IEEE 802.11
Wireless Access Method and Physical Layer Specifications

Title: **Power Management in an Ad Hoc Network**

Abstract: This submission provides ad hoc network power management text for the draft standard.

Figure 7-6: Ad Hoc Power Management - Basic Operation

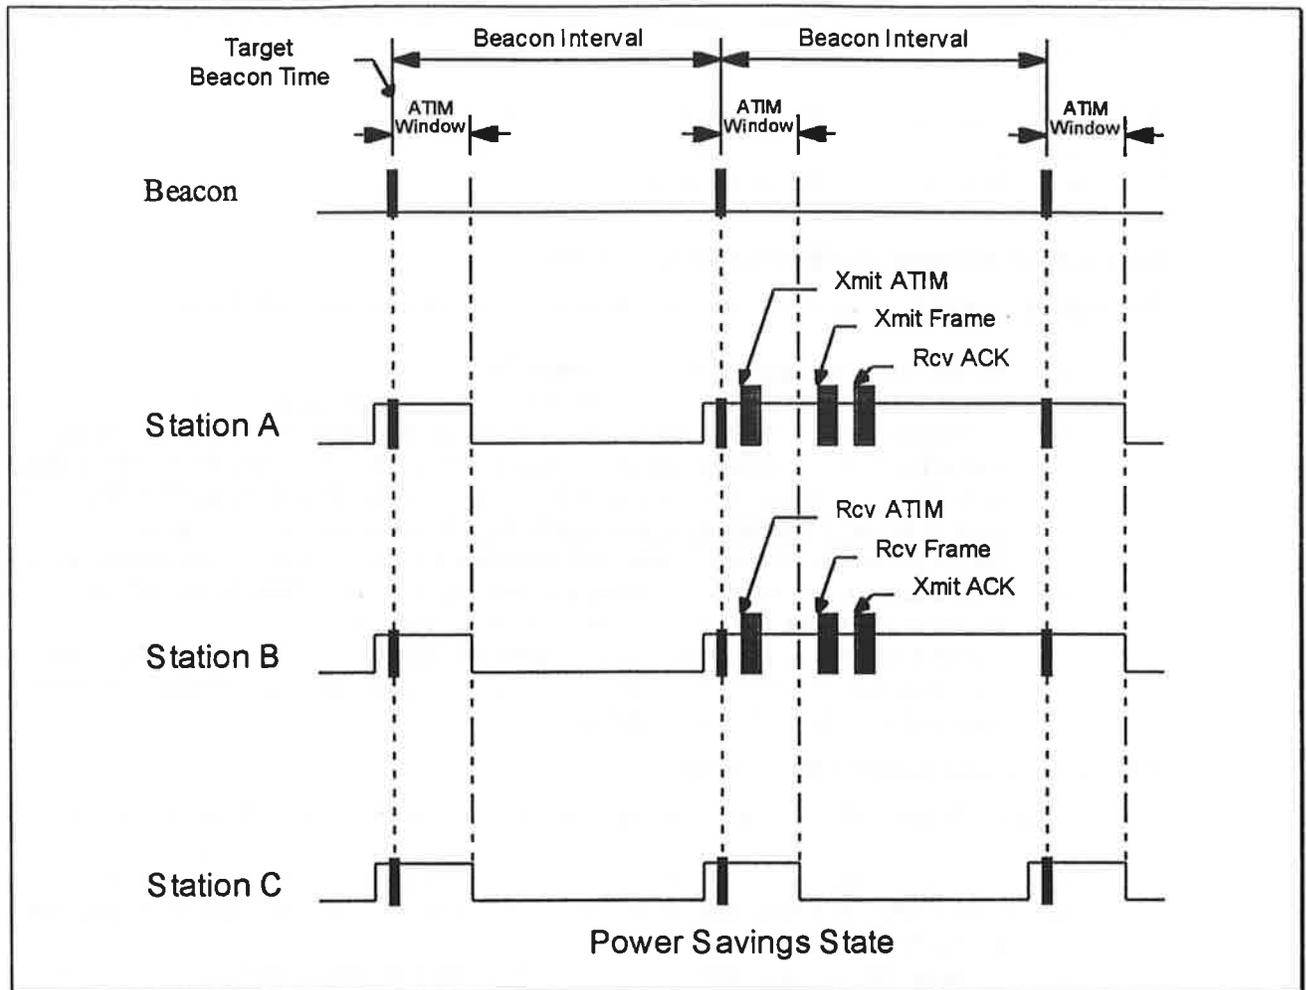
When a frame is to be transmitted to a destination station that is in a Power Save (PS) mode, the transmitting station first transmits an ATIM frame during the ATIM Window, in which all the stations including those operating in a Power Save (PS) mode are awake. The ATIM Window is defined as a specific period of time following a beacon during which only ATIM frames can be transmitted using the DCF Access procedure. The ATIM is not acknowledged. If a station receives an ATIM frame during the ATIM Window, it will stay awake for the entire Beacon Interval waiting for the frame to be received. If a Station does not receive an ATIM, it can go back to PS Mode after the end of the ATIM Window.

The following figure illustrates the basic power save operation.
